Modification	At what stage is this document in the process?
<p>DCRP/MP/18/01/Report to Authority</p> <p>Revision to Engineering Recommendation P28 “Voltage fluctuations and the connection of disturbing equipment to transmission systems and distribution networks in the United Kingdom”</p>	
<p>The purpose of this report is to assist the Authority in its decision to implement the proposed modifications to the Distribution Code and Engineering Recommendation P28 (subsequently referred to as EREC P28). The proposed modifications were subject to industry consultation in January 2018. Responses from this consultation show that the industry is in favour of these modifications.</p> <p>Date of publication: 17th May 2018</p>	
<p>Recommendation</p> <p>The Distribution Code Review Panel (DCRP) and the distribution network licencees recommend that modifications are made to the Distribution Code and Engineering Recommendation P28, in relation to voltage fluctuations resulting from the connection of disturbing equipment to transmission systems and distribution networks in the United Kingdom that address the following:</p> <ol style="list-style-type: none"> a) Introduce requirements and planning le

Figure 5 — Voltage characteristic for frequent events (Category 1)

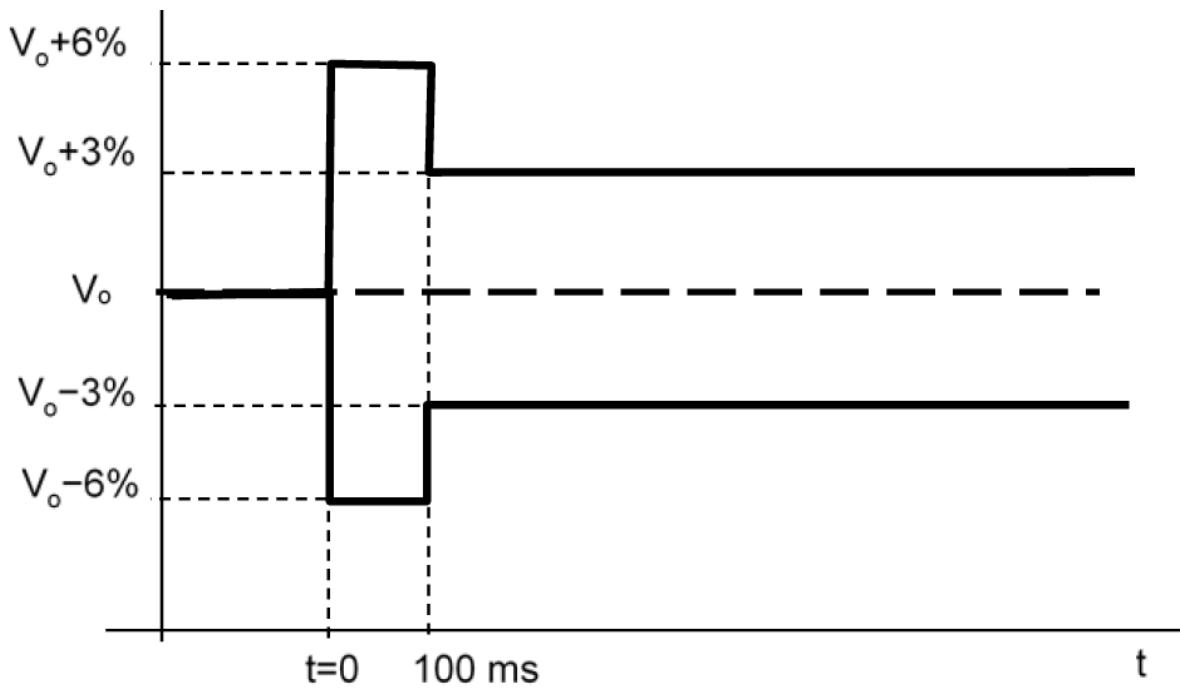
4.2.11 The minimum interval between frequent events fitting within the envelope in Figure 5 is determined by conformance to flicker severity (P_{st}) limits in EREC P28 Issue 2.

a) The apparent setting of planning levels the same as operating levels for the higher categories of RVCs concerned one respondent because when the network is not operating correctly, equipment could be constrained off for long periods due to external events causing them to trip off.

i) In response, the Working Group do not believe the requirements in EREC P28 Issue 2 are more onerous than Category 2 of Grid Code CC.6.1.7. The time and voltage magnitude limits for Category 3 RVCs shown in Figure CC.6.1.7 of the Grid Code when compared with Figure 7 of EREC P28 Issue 2 confirm that both the time and voltage limits in EREC P28 Issue 2 for Category 3 very infrequent events (not more than 4 RVCs in 1 day providing less frequent than once every 3 calendar months) are less onerous than those for Category 3 RVCs in the Grid Code.

i) In response the Working Group believe there would be no realistic prospect of operation of the G59 undervoltage stage 1 protection for external RVC events that conform with the limits and requirements of EREC P28 Issue 2. Furthermore, the reference to "Commissioning, maintenance and post fault switching" in Table 4 of EREC P28 Issue 2 is an example of applicability. NOTE 7 in Table 4 states that these are examples only and that customers may opt to conform to the limits of another category providing the expected frequency of the events do not exceed the maximum frequency permitted for the chosen category. Commissioning, maintenance or post fault switching activities could be classed as Category 1, Category 2 or Category 3 events depending upon the maximum number of occurrences foreseen for those events.

Subsequent to their initial response the Working Group would point out that Table 4 of EREC P28 Issue 2 refers to planning levels for RVCs, which should be used for design and planning of connections. Whilst design pre-connection should be based on an expected number of both planned and unplanned RVCs over specified time periods to comply with Table 4, it is recognised that Users do not have control of the number of actual unplanned RVC events, including G59 trips, that could occur post connection.

Figure 6 — Voltage characteristic for infrequent events (Category 2)

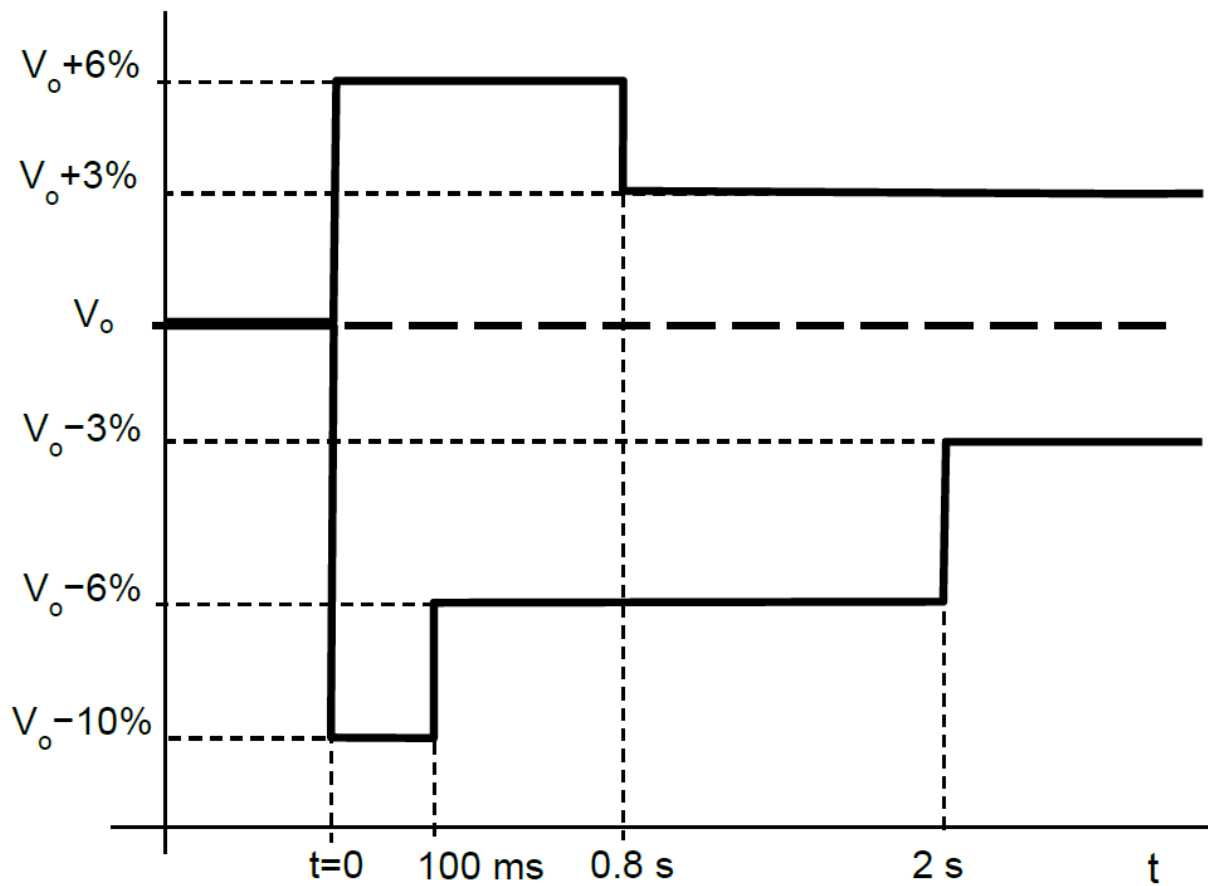
4.2.12 Up to 4 RVC events per calendar month are permitted for voltage fluctuations fitting within the envelope in Figure 6.

- EREC P28 Issue 2 introduces an intermediate category of RVC (Category 2) for 'infrequent events', where up to a maximum of 4 RVCs in one day are permitted not more frequent than 4 times per month providing the $\Delta V_{\max} \leq -10\%$ for ≤ 100 ms then reducing to $\leq 6\%$ for up to 2 s after initiation of the event (see Figure 6).

Figure 7 — Voltage characteristic for very infrequent events (Category 3)

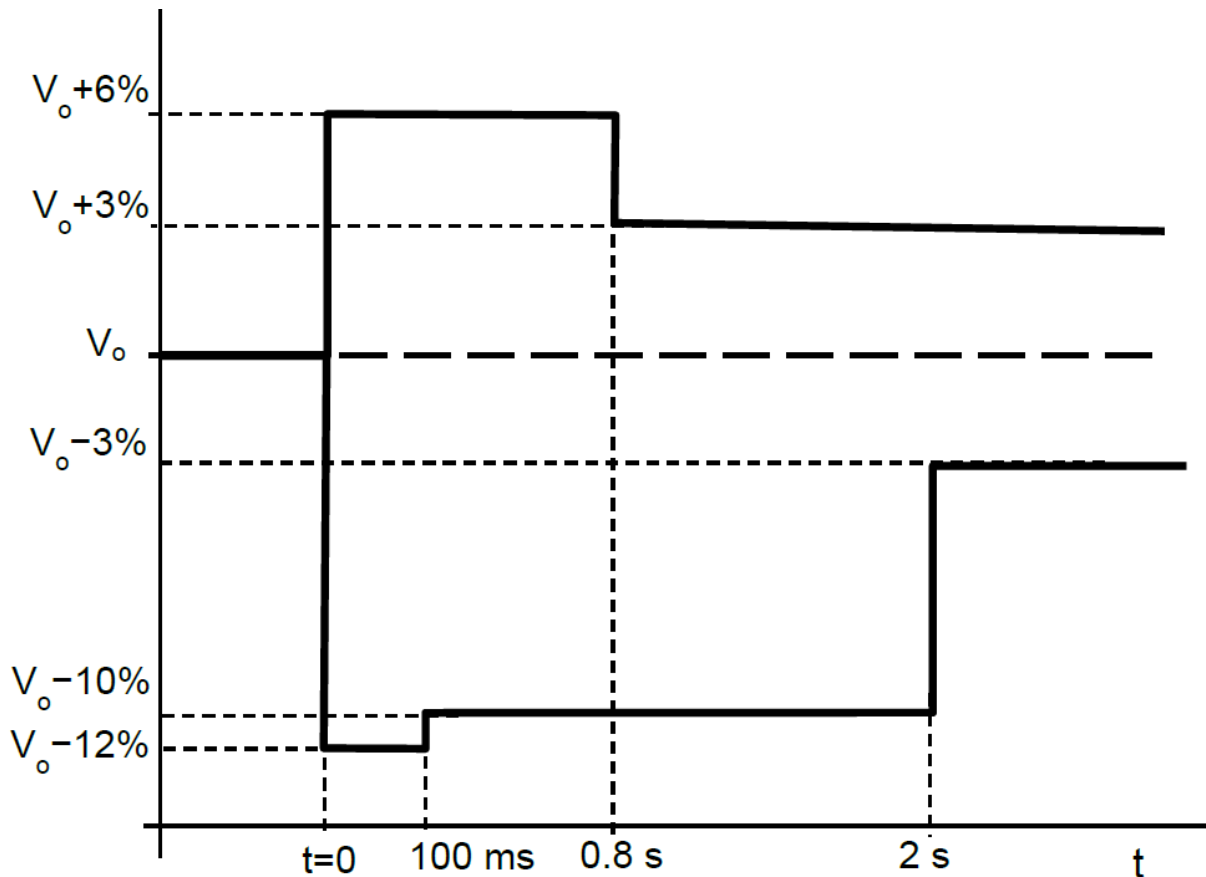
- Allowable voltage changes are expressed as a percentage of nominal voltage (V_n) in P28 Issue 2 as opposed to a percentage of the initial voltage (V_o) in the Grid Code. The intention being to align with the approach taken in National and International Standards.
- For increases in voltage:
 - EREC P28 Issue 2 proposes a limit on the maximum voltage change between two steady state conditions of $\Delta V_{\max} \leq 6\%$ for a maximum duration of 0.8 s from the initiation of a voltage change.
 - The Grid Code has a limit of $\Delta V_{\max} \leq 5\%$ for a maximum duration of 0.5 s.
- For decreases in voltage:
 - EREC P28 Issue 2 proposes a time limit of 100 ms from initiation of a

voltage change during which the maximum voltage change permitted (-12% for 'very infrequent events' and -10% for 'infrequent events') can persist.

- The Grid Code has a time limit of 80 ms from initiation of a voltage change during which the maximum permitted voltage change is -12%.
- For increases and decreases in voltage, EREC P28 Issue 2 permits a greater maximum number of occurrences for Category 3 'very infrequent' events:
